Access Compliance Report Public Rights-of-Way (Curb Ramps)

Main Street: WINDSOR_LN Cross Street: RED_HILL_AVE Location: S

ADA ID: RPRK211014173251 Ramp Type: Type 6 - Directional 1 Initial Pass/Fail: Pass Overall Compliance: No Severity Score: 6

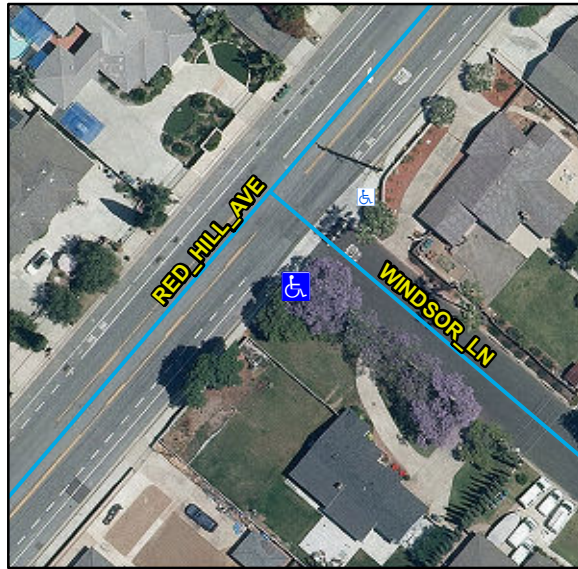
Possible Solutions:

Remove & Replace Entire Ramp. Remove & Replace Gutter.

R304.2.2, R304.2.1, R304.5.3, STD 1115
